**ADDENDUM NO. 3  
TO PLANS AND SPECIFICATIONS FOR THE  
ALPENA WATER PRODUCTION PLANT (WPP) CLEARWELL REPLACEMENT  
& INFRASTRUCTURE IMPROVEMENTS**

**ISSUED:** March 13, 2024

HRC Job No. 20220751

FLOW DIAGRAM

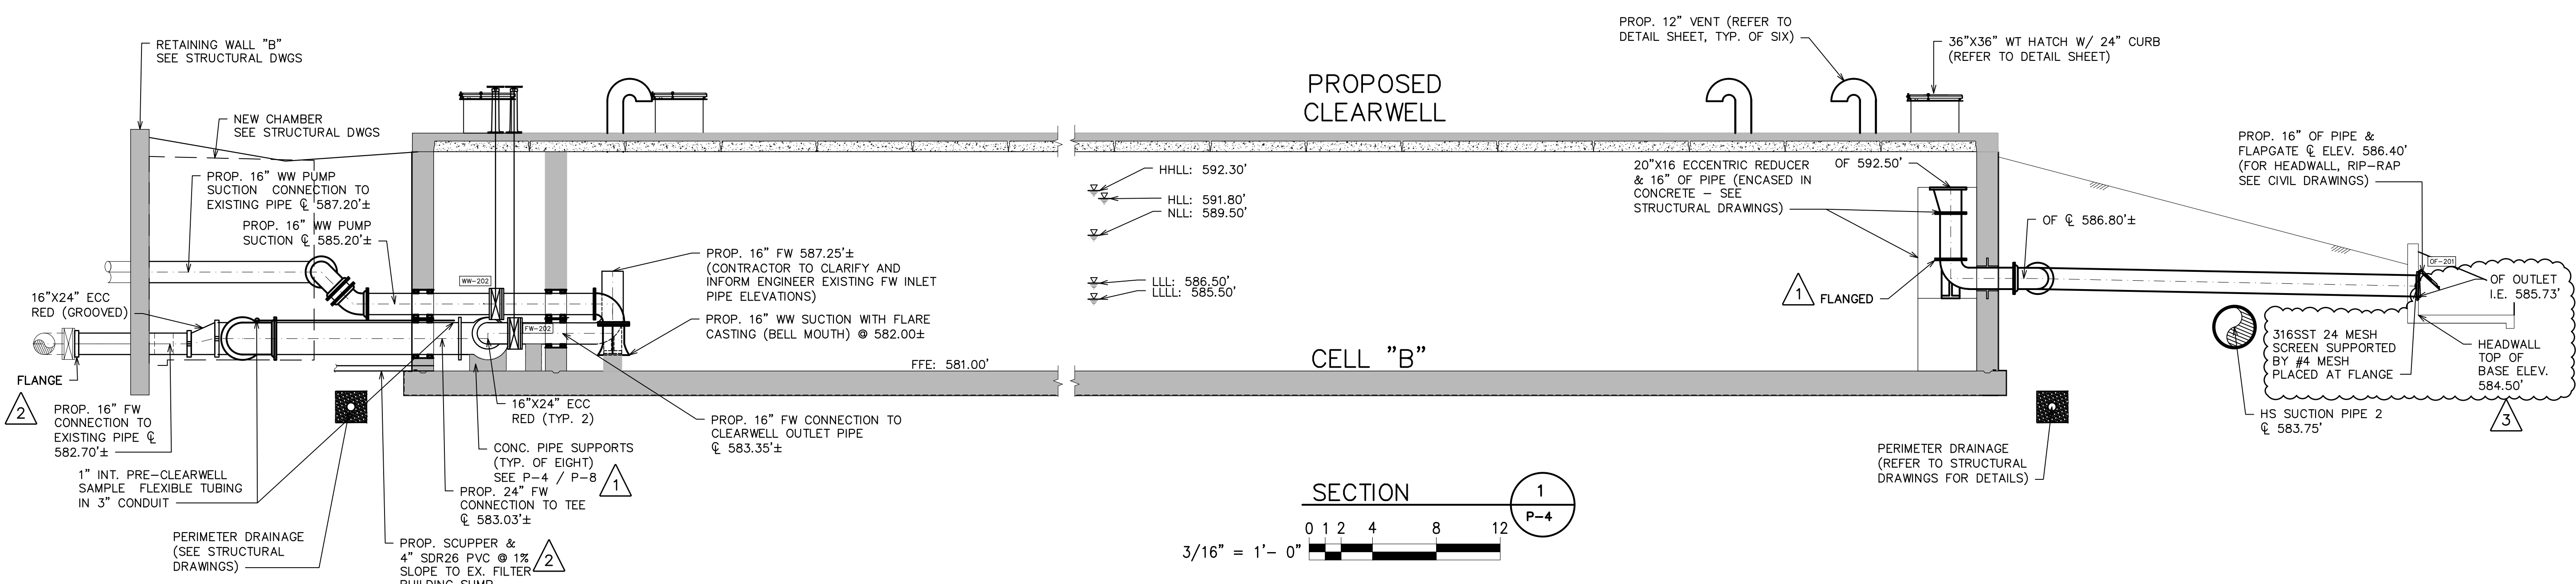
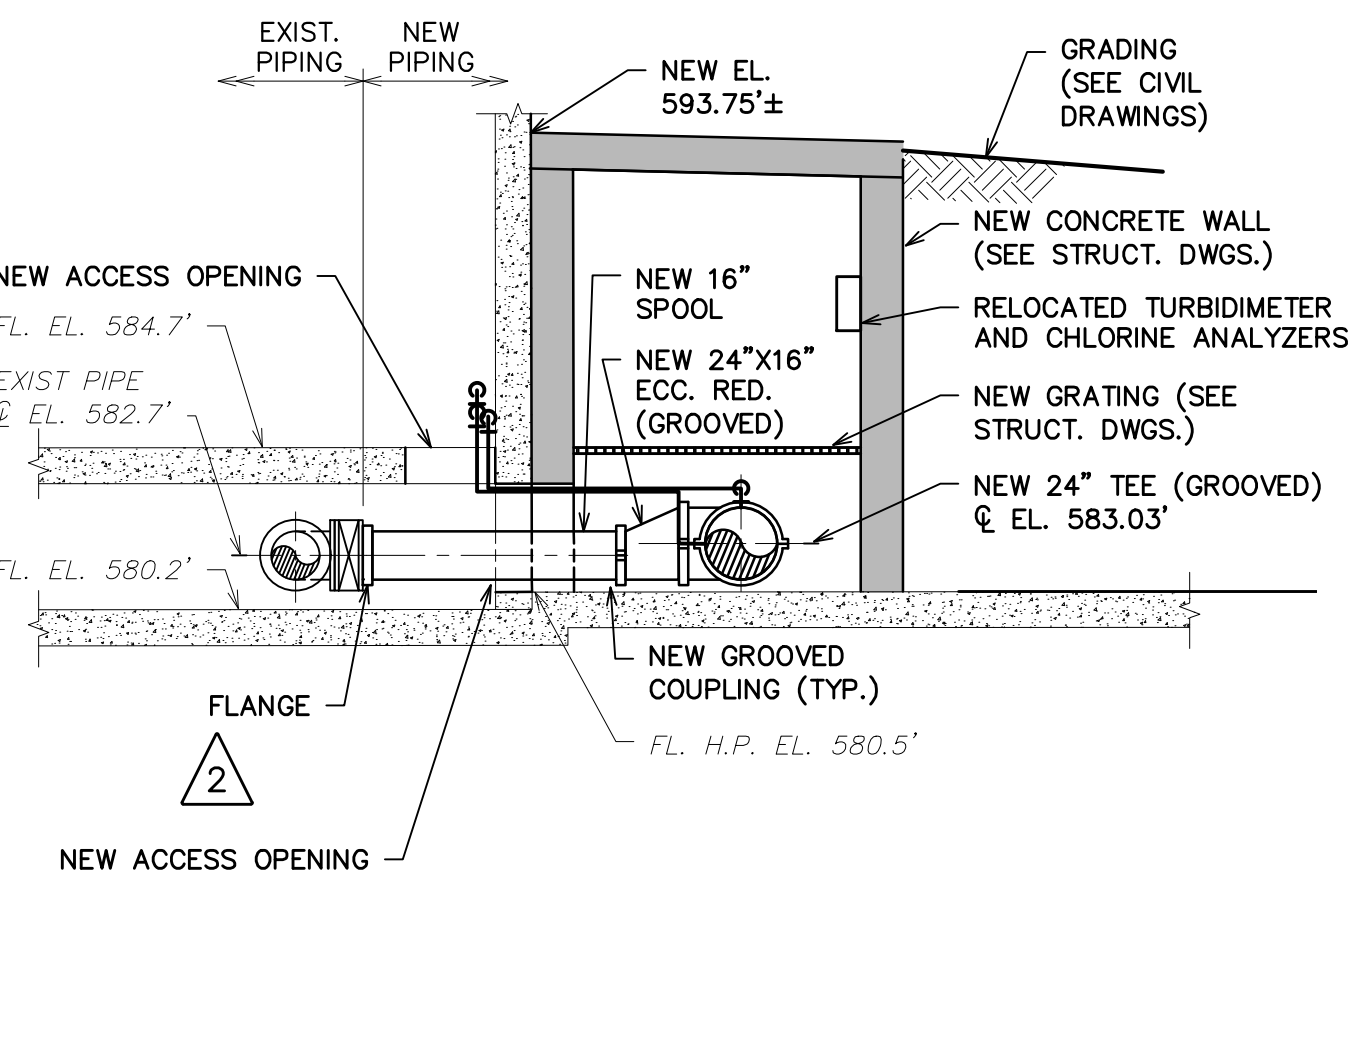
1. SHEET P-5 (Issued) – See updated sheet.
2. SHEET P-9 (Issued) – See updated sheet.
